BID PACKAGE 02 – ADDENDUM 01**Date:** January 10, 2020**Re:** Wilma P Mankiller Health Center Expansion**From:** James R Childers Architect, Inc.
45 South 4th Street
Fort Smith, Arkansas 72901

CHANGE NARRATIVE LETTER

TO: MATHEW THOMAS- CHILDERS ARCHITECTS
FROM: STEPHEN EDMONDSON, TREY SMITH, BETSY WELLS– HP ENGINEERING, INC.
DATE: 1/10/2020
PROJECT: WPMHC EXPANSION BID PACKAGE 02 ADDENDUM 01

SHEET NUMBER:
M5.05
ENLARGED MECH. ROOM HVAC PLAN

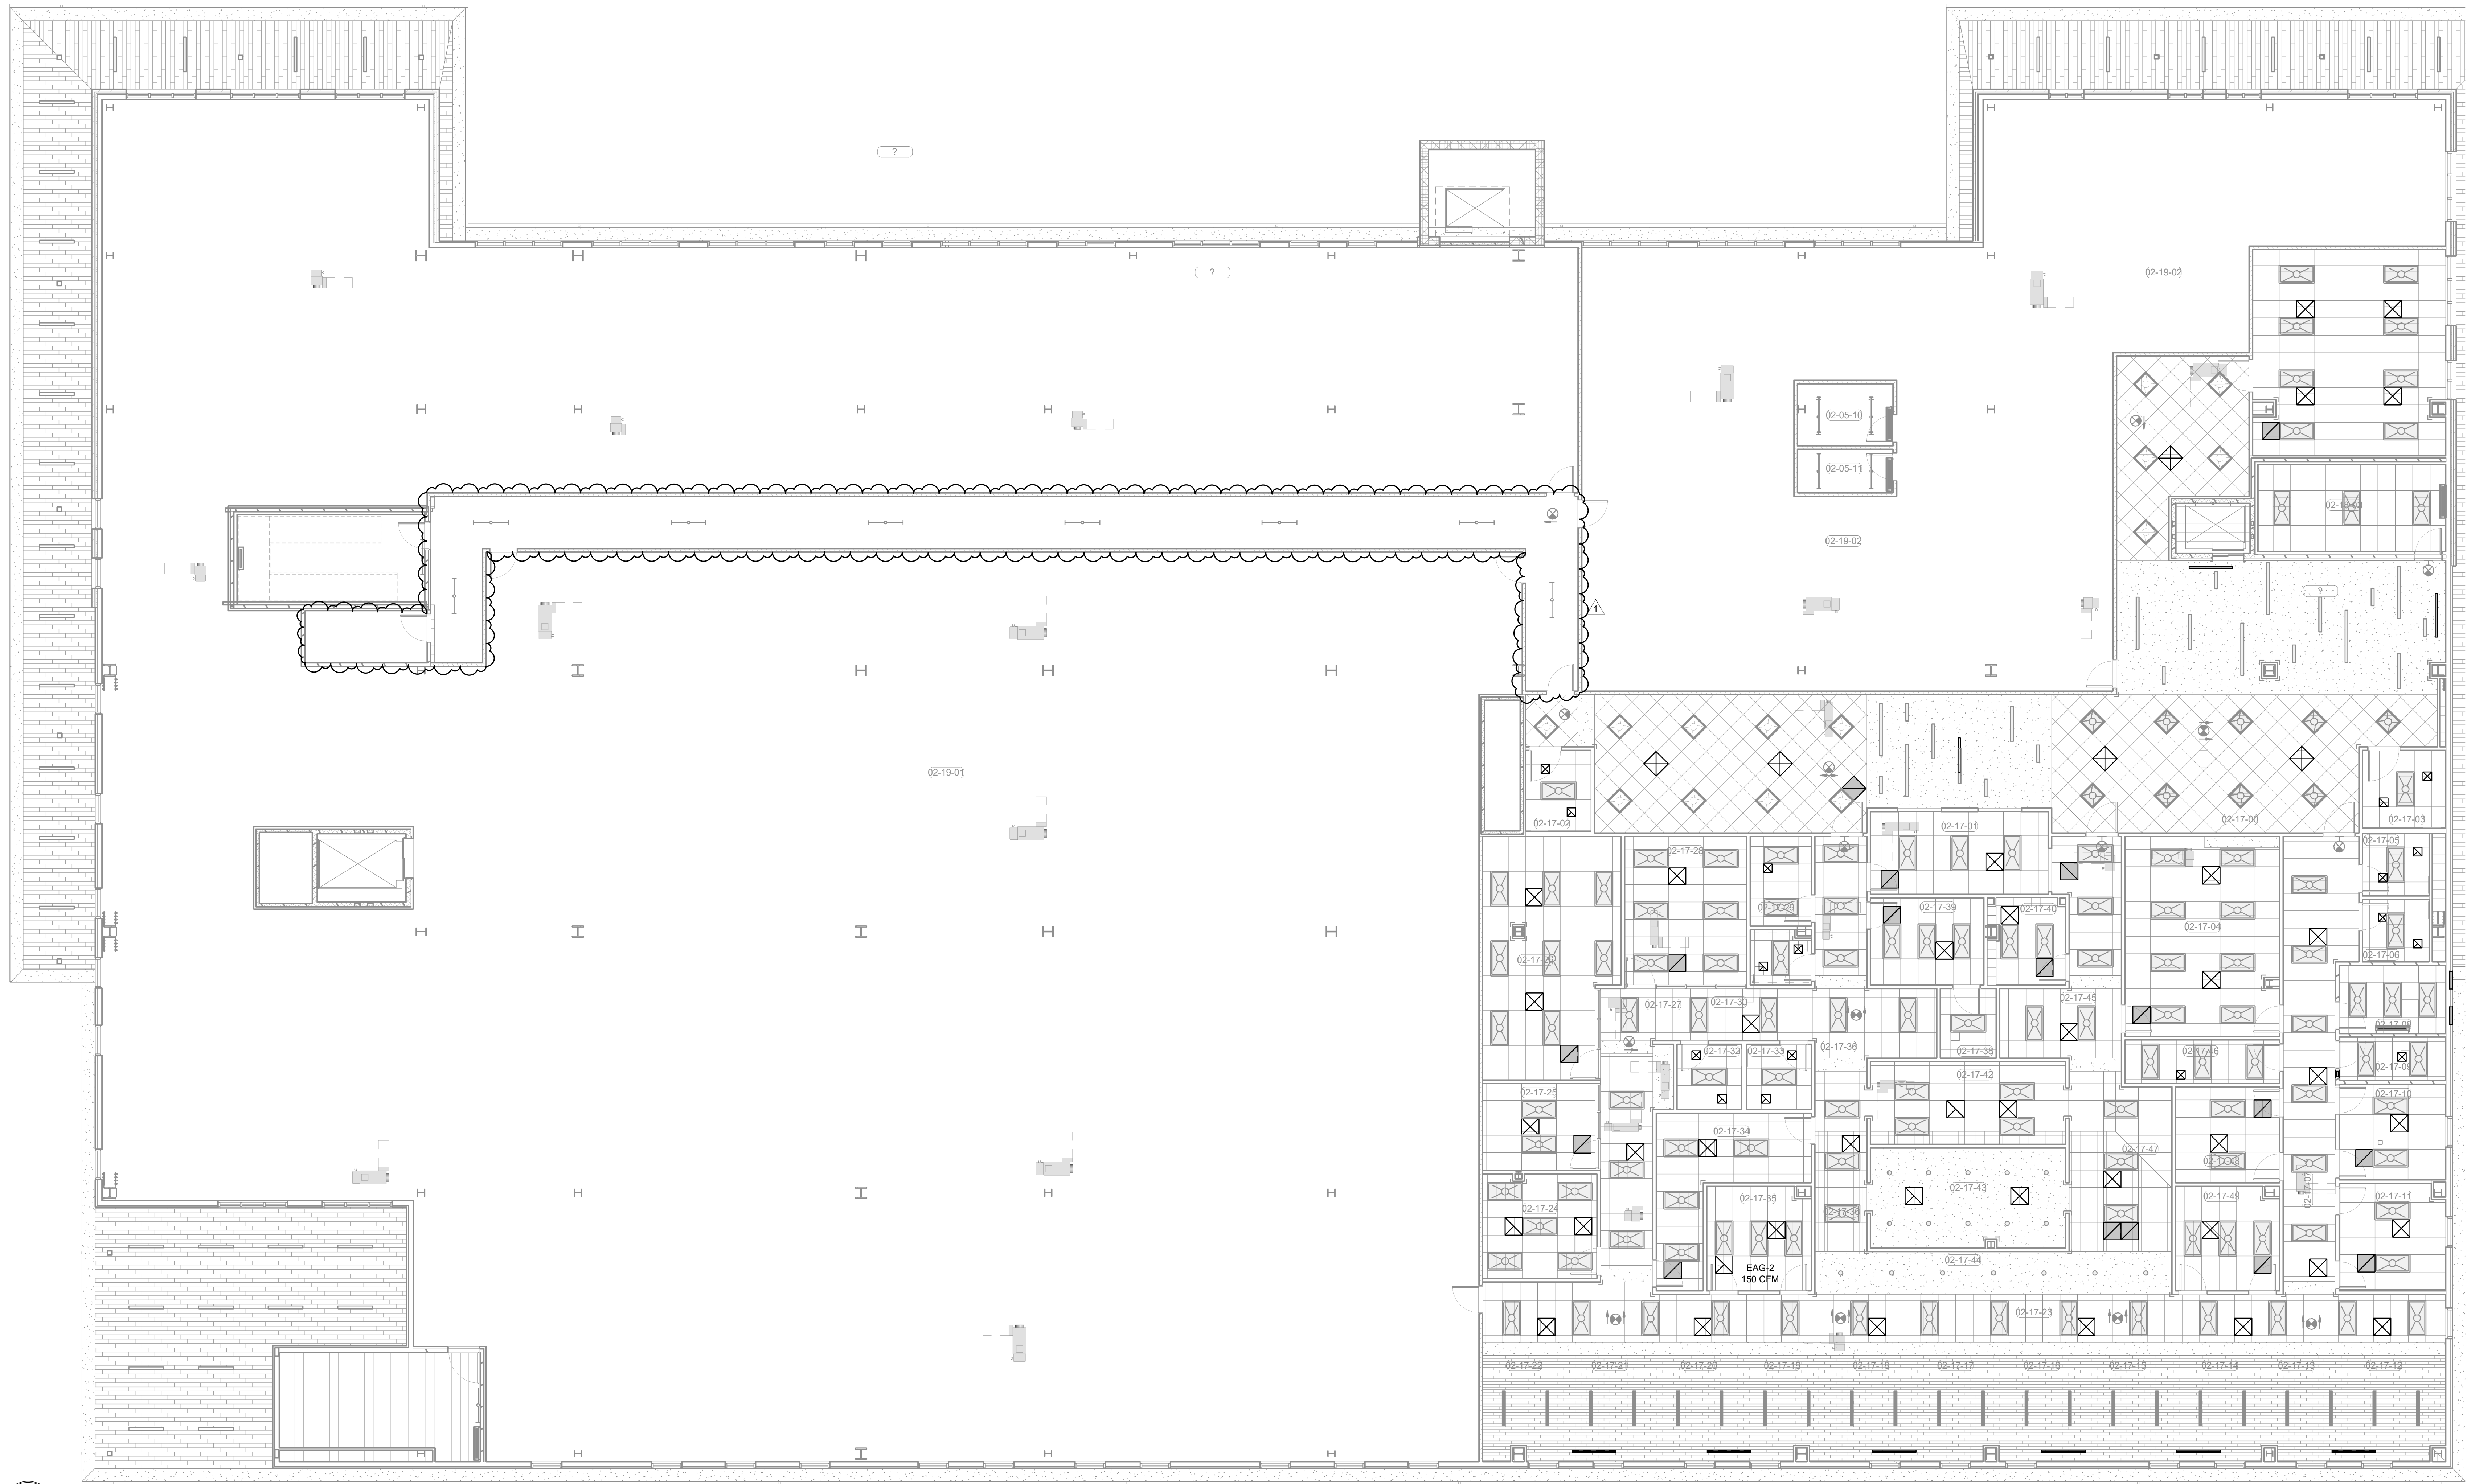
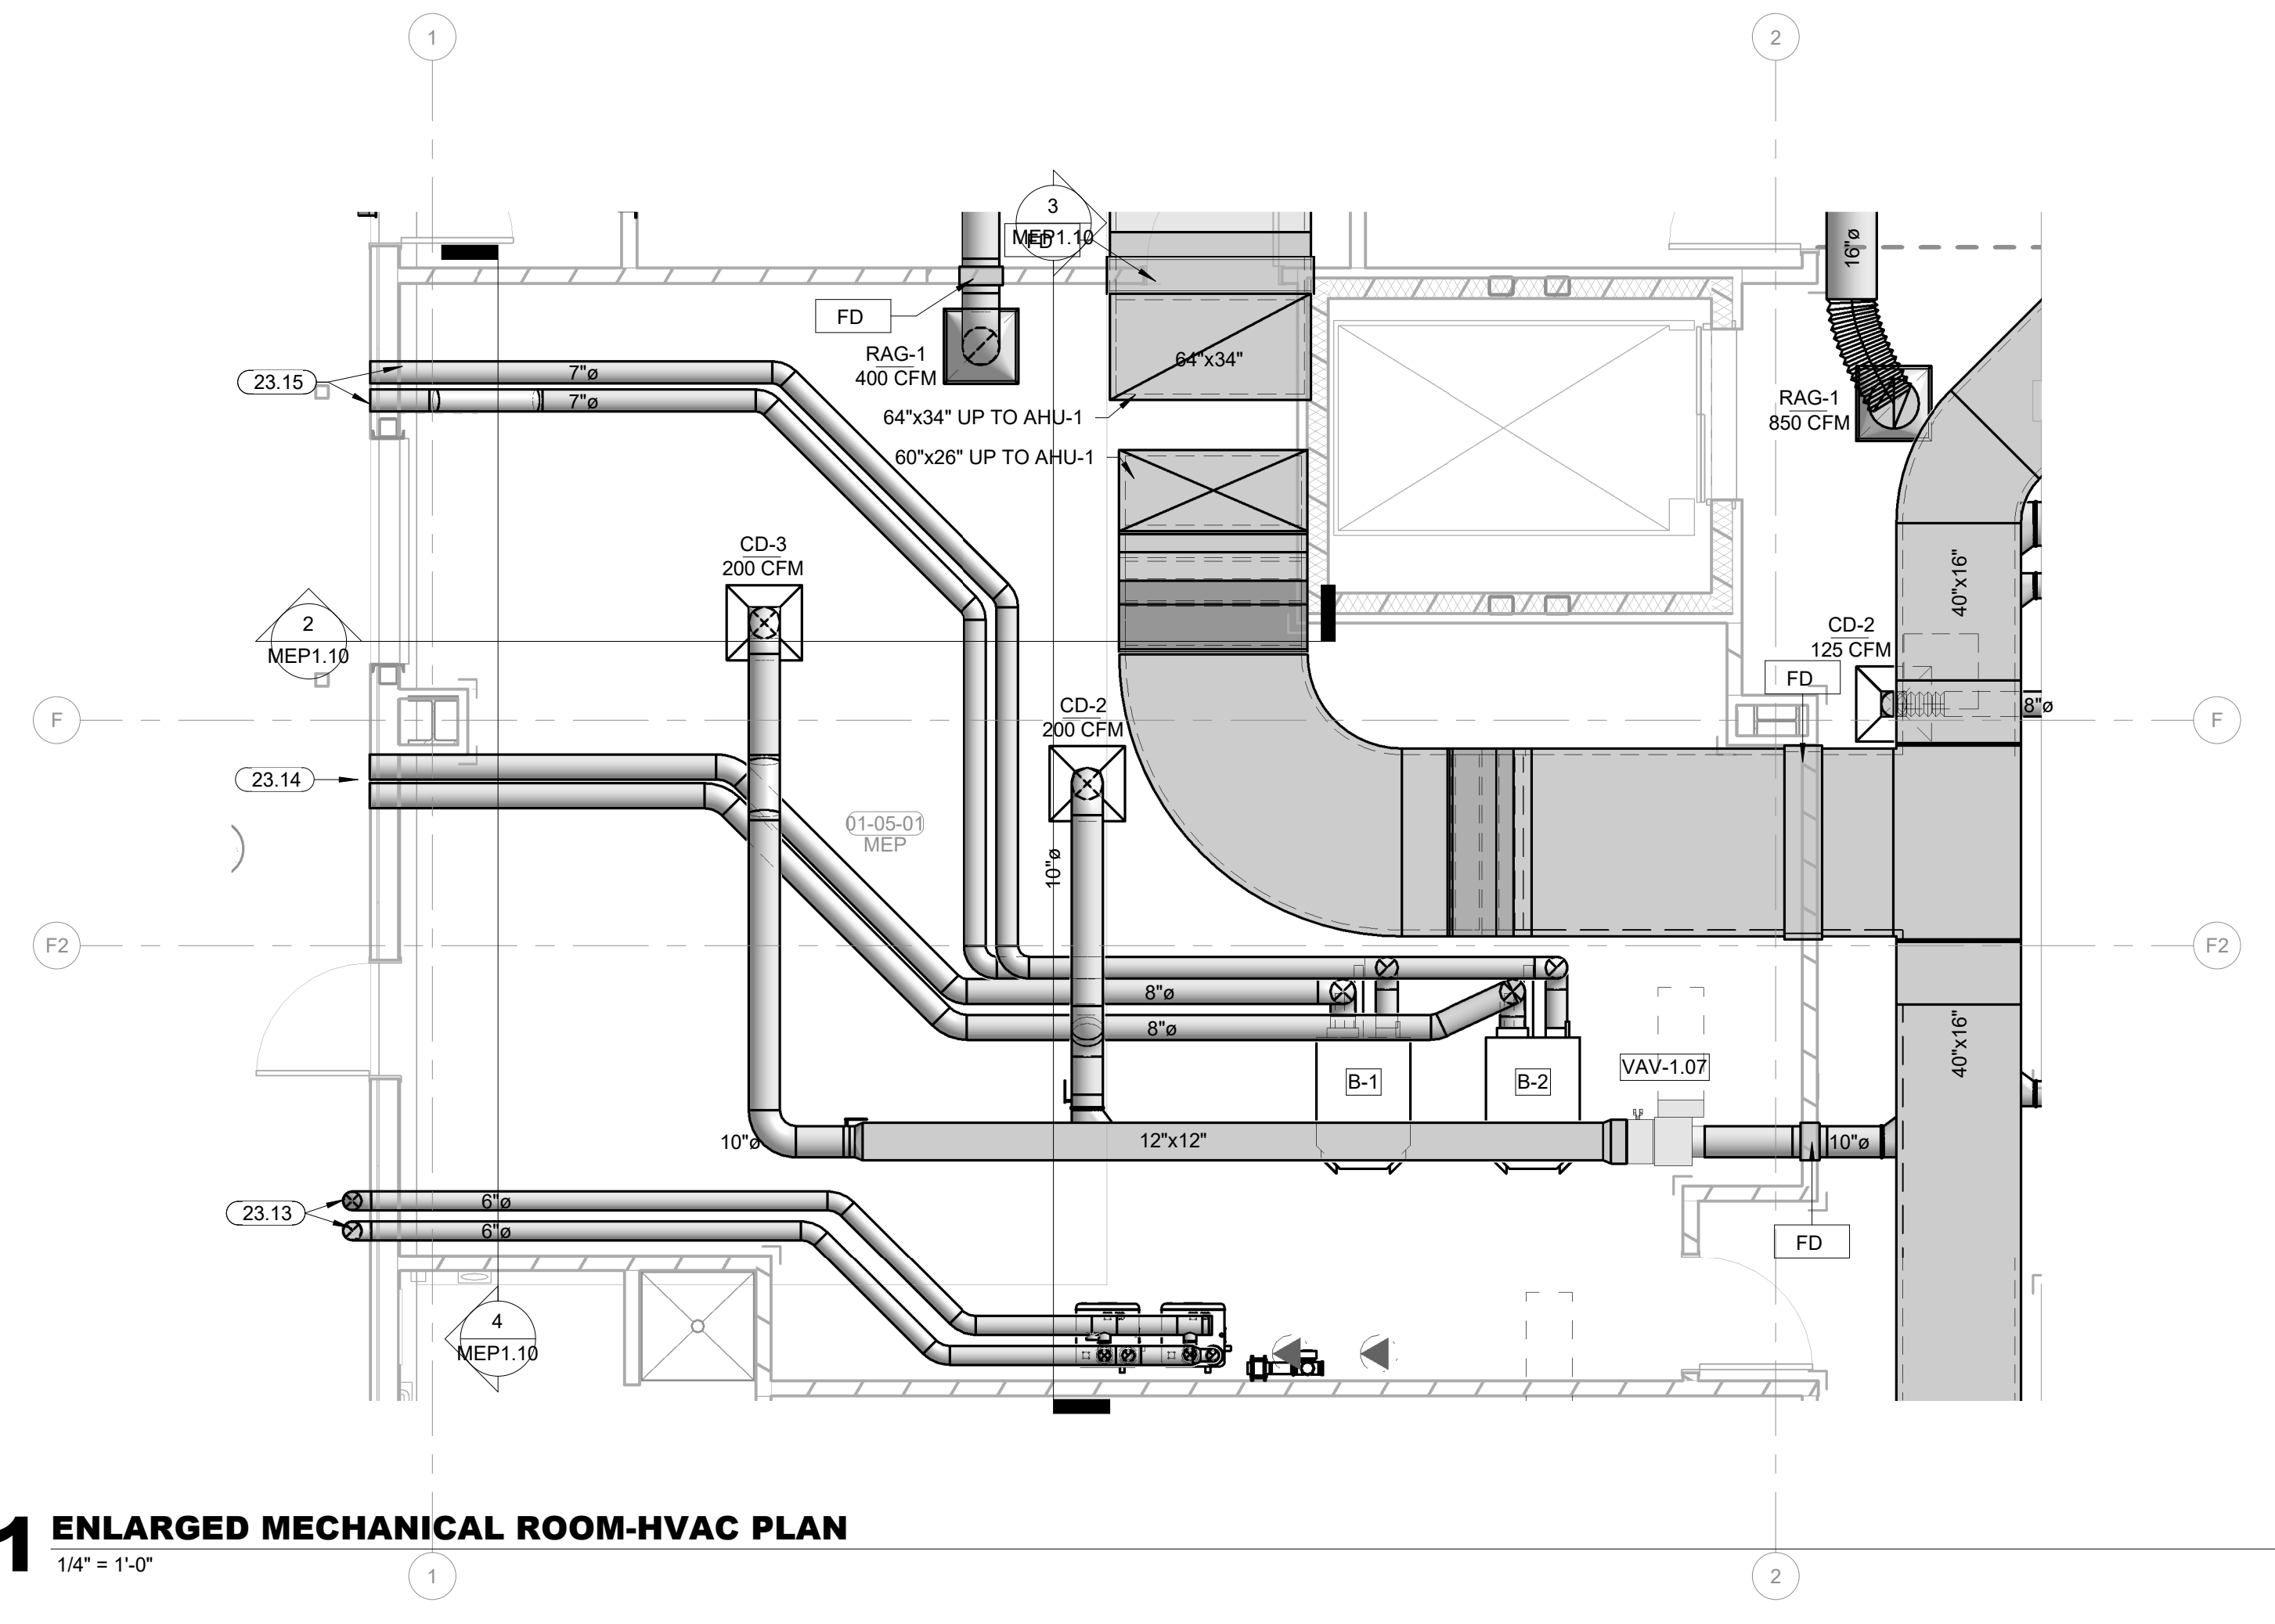
1. M1.02
 - a. Mini Split Air Conditioning Schedule – Revised MCA and MOCP.
 - b. Dental Equipment Louver Schedule – Added schedule to sheet.
 - c. Dental Equipment Exhaust Fan schedule – Add schedule to sheet.
2. M2.03
 - a. Added detail 6 to sheet.
3. M4.02
 - a. Removed ductwork and air devices from corridor.
4. M.503
 - a. Removed ductwork and air devices from corridor.
 - b. Added equipment to dental mechanical room.
5. M5.04
 - a. Removed ductwork and air devices from corridor.
6. M5.05
 - a. Revised hood location.
 - b. Revise air device locations.

SHEET NUMBER:
M6.04

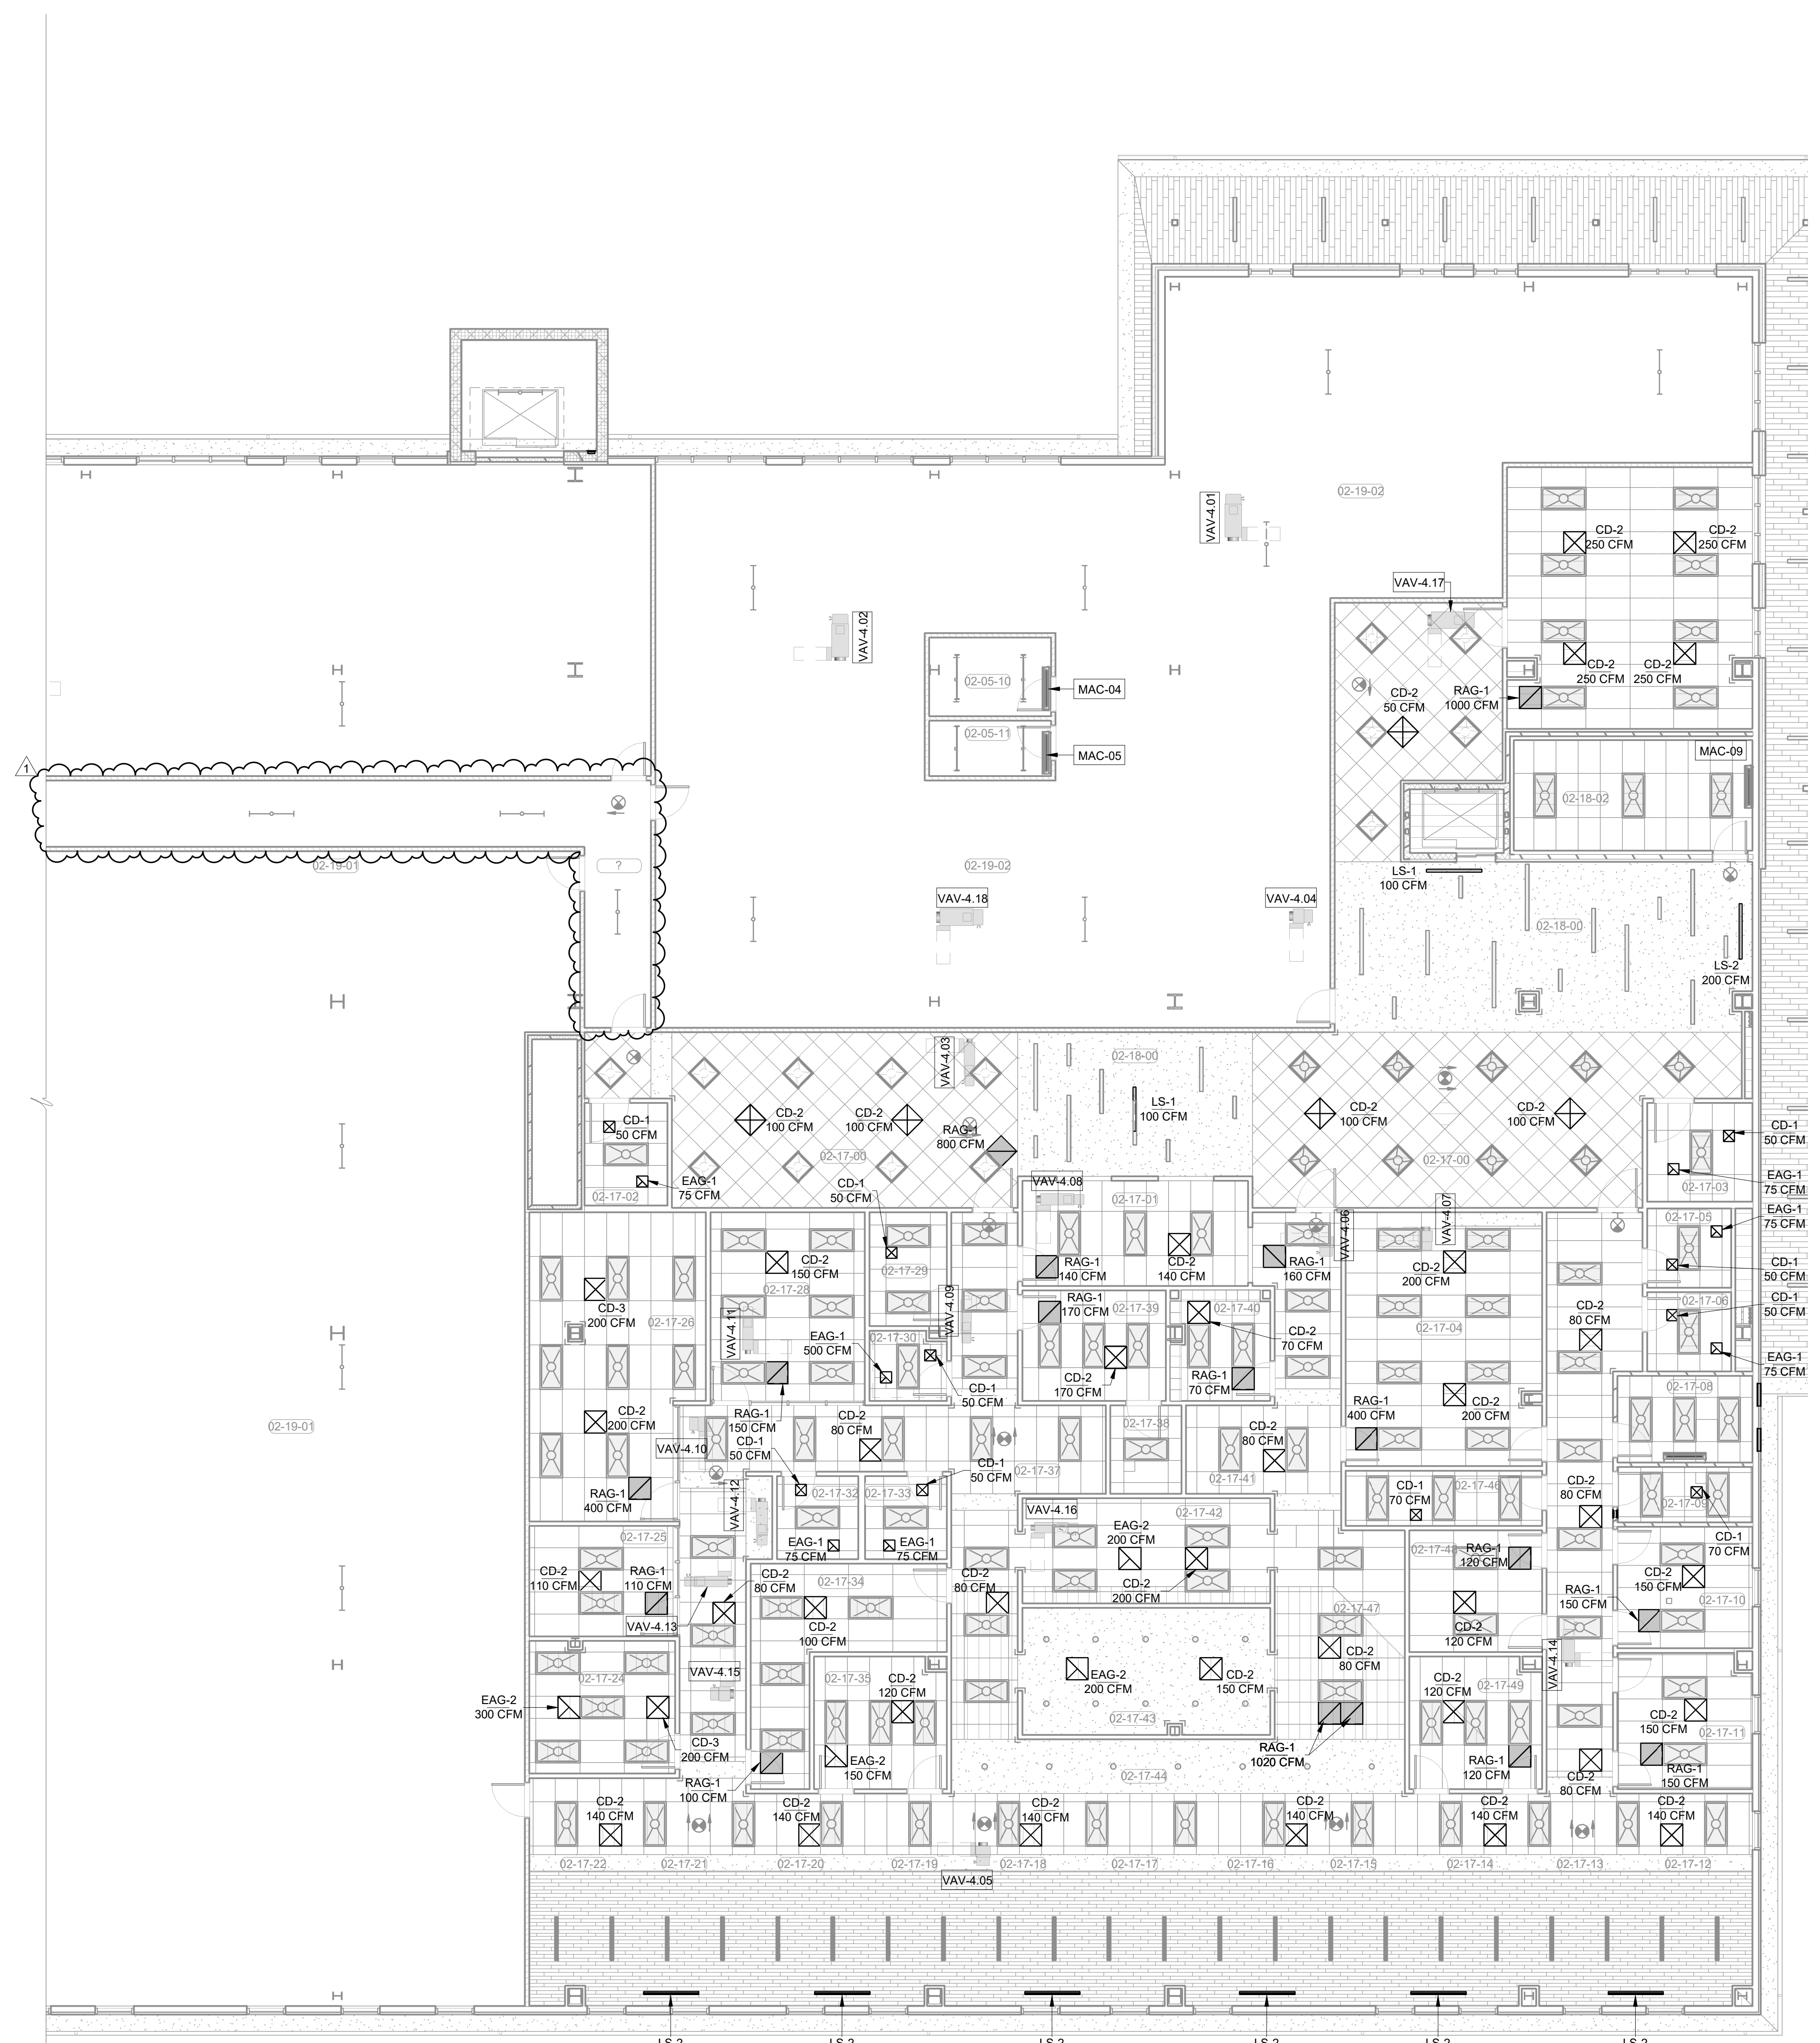
7. M6.04
 - a. Removed air devices from corridor.
8. M6.05
 - a. Removed air devices from corridor.
9. M6.06
 - a. Remove air devices from corridor.
10. M8.01
 - a. Revised hydronic pipe routing to miss electrical equipment.
11. M8.02
 - a. Revised hydronic pipe routing to miss electrical equipment.
12. M8.10
 - a. Added E-stop location for boilers.
13. M8.11
 - a. Added detail callouts for boilers.
